Aldington Developments and its consultant team have reviewed the Draft DCP and has a number of concerns that require additional clarification or reconsideration prior to finalisation of the DCP. These are outlined in the below sections

## Lot 39 DP 708347, 1-23 Aldington Road - CPCP submission

**Figure 2 Lot 39 Vegetation Mapping**

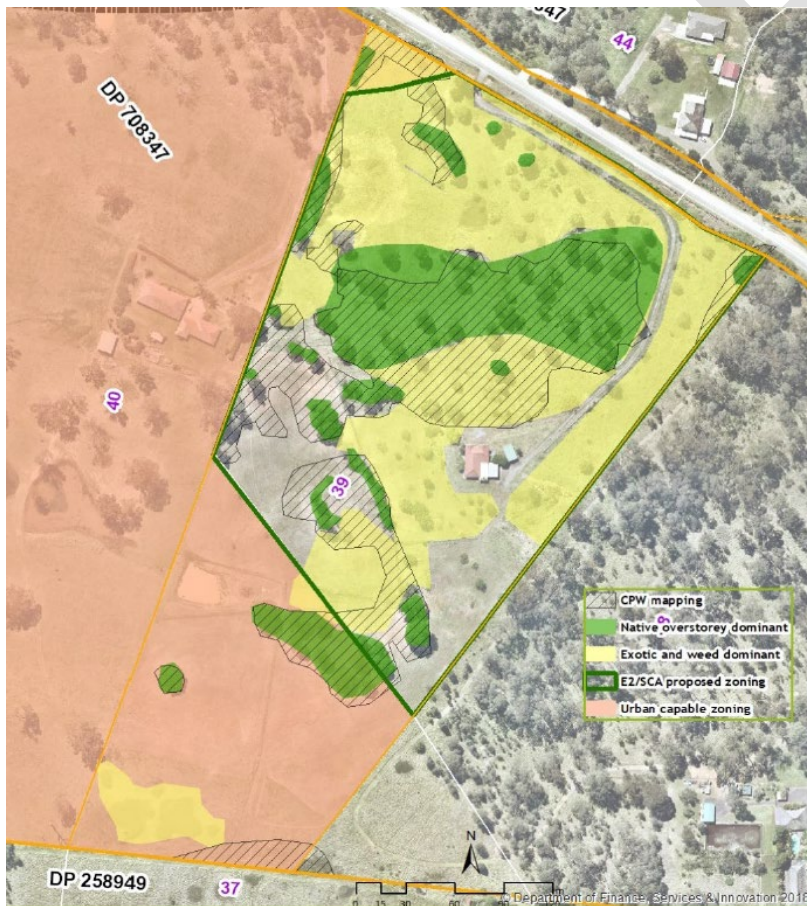
Aldington Developments engaged ecology firm Ecologique to undertake vegetation mapping of the site in July and October 2020. Correspondence from Ecologique is at **Appendix A**. The surveys found that the proposed E2 zone / high value biodiversity area on Lot 39 is dominated by exotic plant species and trees associated with the site's former agricultural uses, including a former orchard of which some trees remain on the site. The native canopy only comprises 21% of the lot or 1.48 hectares. The vegetation mapping derived from the survey is shown in **Figure 2**.

- **Department give serious consideration to the evidence presented in the Ecologique report (Appendix A) with a view to a review of the E2 zoning on Lot 39.**
- **The Mamre Road Precinct Structure Plan be revised to remove the *Opportunity for ecological corridor* designation on Lot 39.**

Figure 1. Vegetation mapping on Lot 39

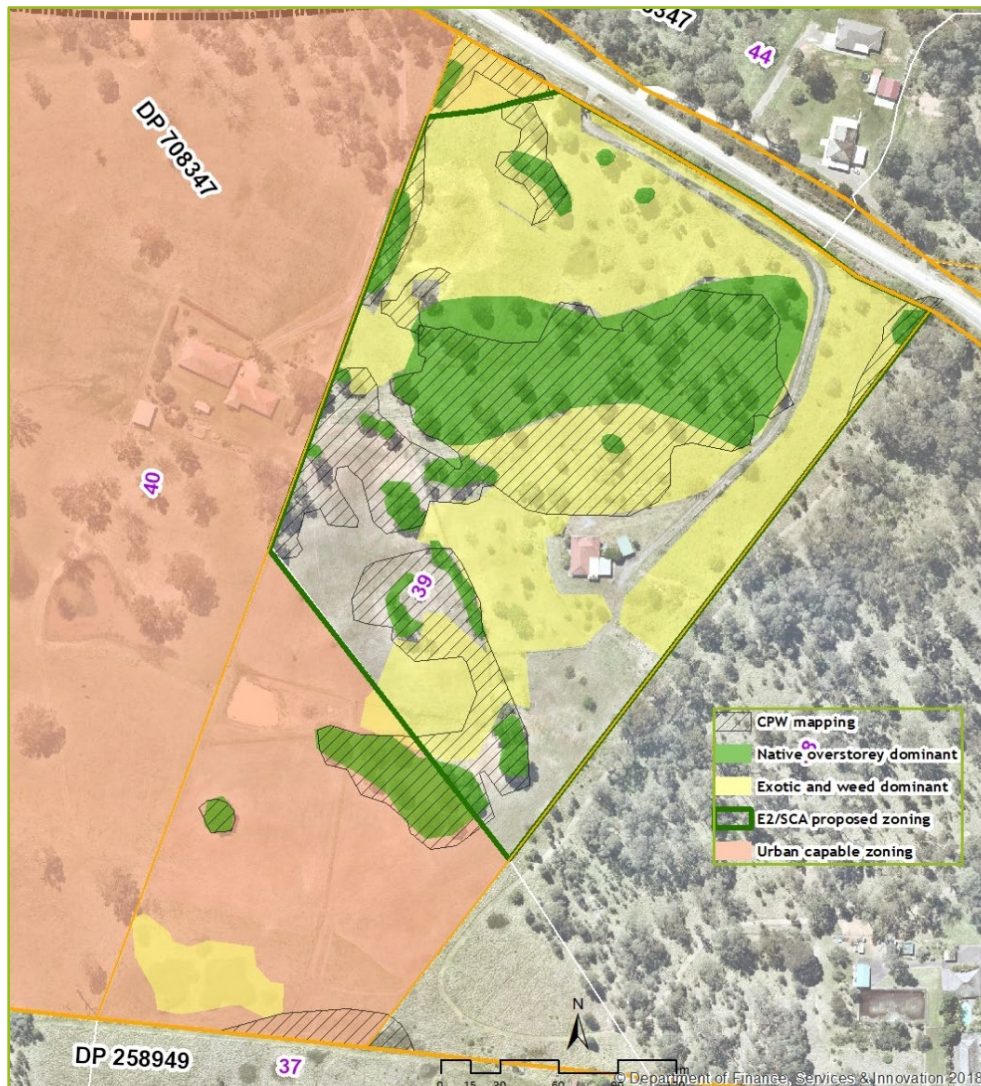
Generally, Lot 39 comprises large areas that are dominated by exotic planted and orchard trees and an understorey of pasture grasses and weeds (including priority weeds such as but not limited to: Blackberry, African boxthorn and African lovegrass). Areas that are dominated by CPW tree species comprise approximately 21% of the land proposed as a Strategic Conservation Area (SCA) on Lot 39.

As shown in Figure 1, mapping undertaken on the 10<sup>th</sup> October 2020 coincides with a proportion of the draft CPCP mapping, with the exceptions of the extent of CPW in the mid and southern areas of the proposed SCA land. The areas mapped on the 10th October 2020 that conflict with the draft CPCP mapping, were found to be dominated by exotic canopy and groundlayer species

Figure 2. DRAFT CPCP intended corridor from South Creek to Ropes Creek (spatial viewer extract) SCA zoned land on Lot 39 in red boundary)

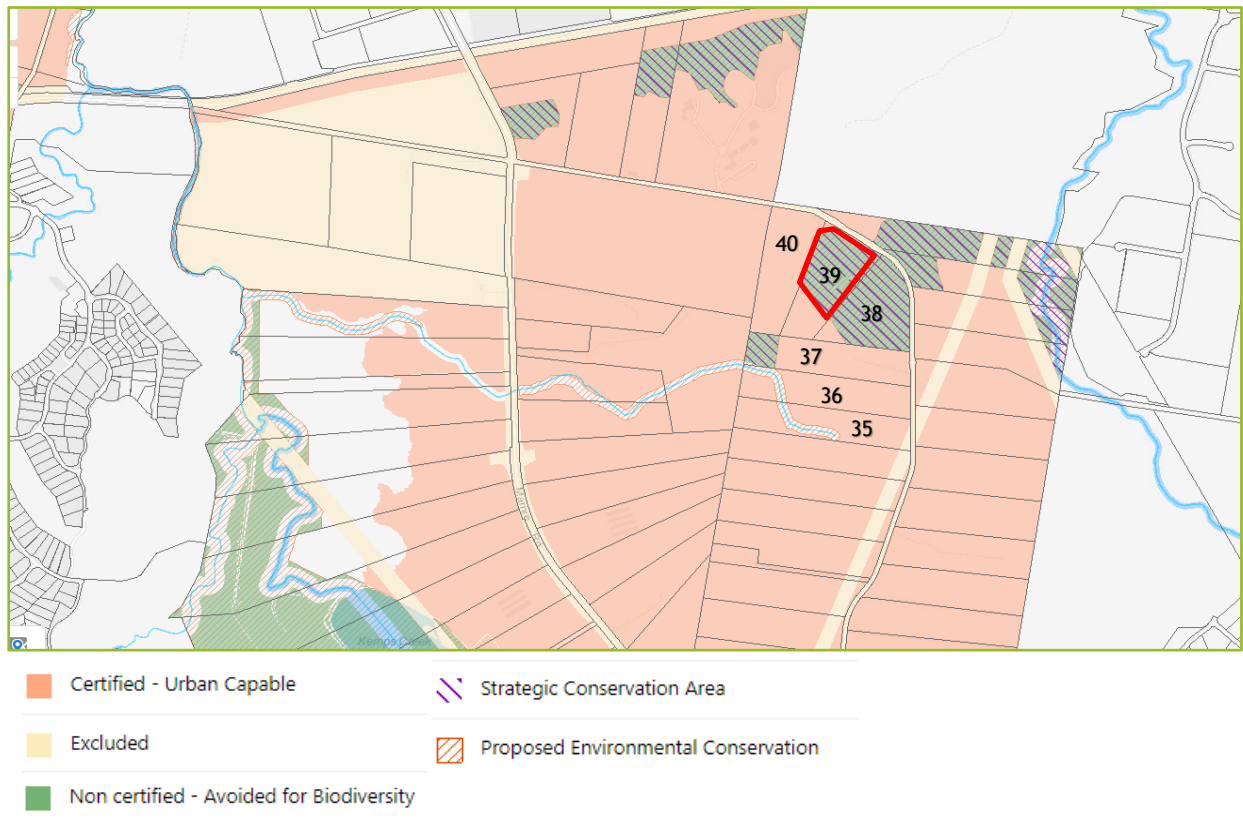
As shown on Figure 2 the proposed ecological link is a narrow riparian corridor proposed as E2, which extends from South Creek and terminates approximately 1km to the west of Ropes Creek Lot 35 DP 258949.

The distance between the proposed SCA zoning on Lot 37 DP 258949 and Lot 38 DP 708347 is greater than 200m and greater than 300m from native vegetation on Lot 39 DP 708347.

**The proposed corridor to the south of the subject site is a blind corridor (as shown on Figure 2). While Lot 39 is suitably located adjacent to bushland on Lot 38 it is not contiguous with the proposed ecological corridor to the southwest and south as discussed in Section 2.**

Figure 3. Ecological constraints

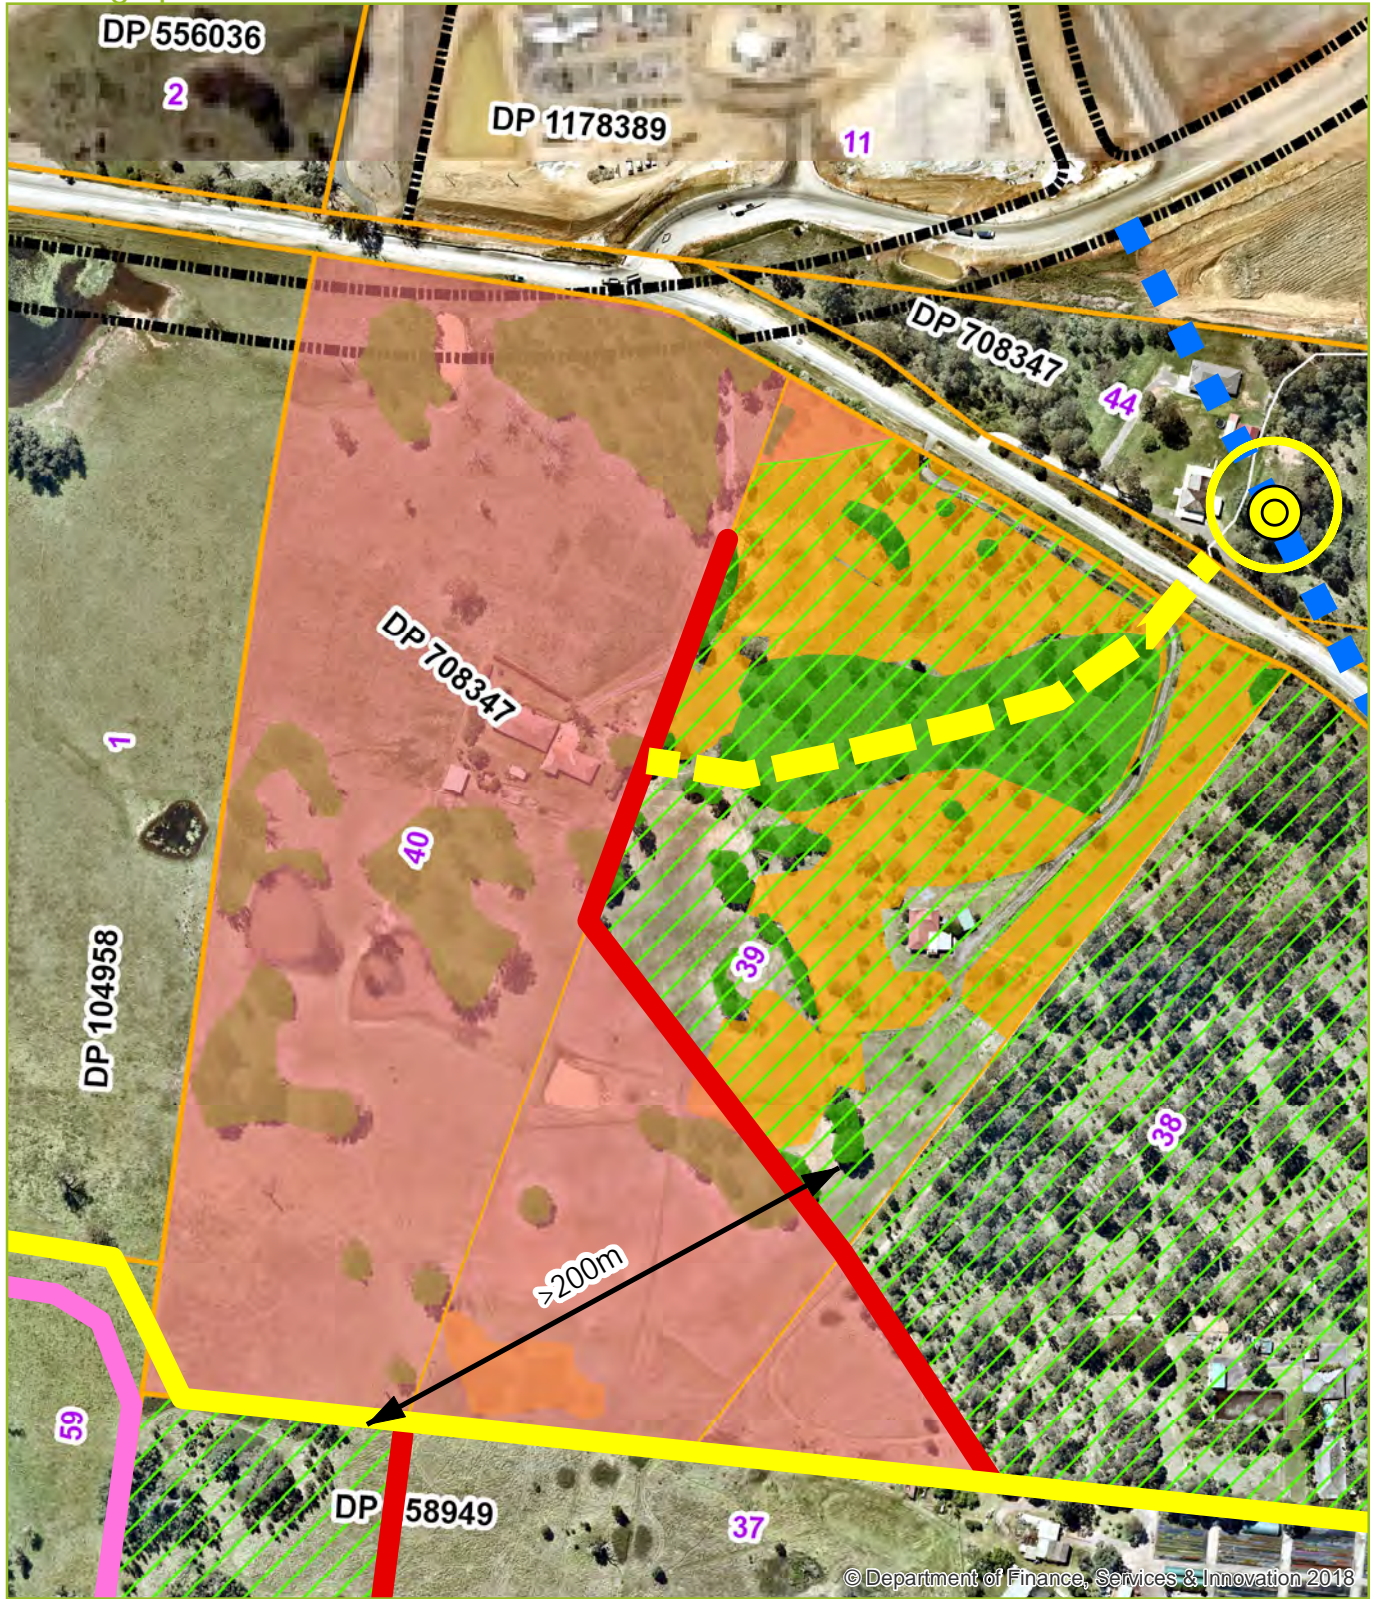
These gaps will be further isolated by proposed arterial road connections, high order and internal roads as shown in Figure 3.

The current width of the road and road easement immediately north of Lot 39 DP 708347 has a minimum width of 21.5m and maximum width of approximately 28m. This will not be wide enough for the proposed upgrade and will further impact on the areas proposed as SCA.
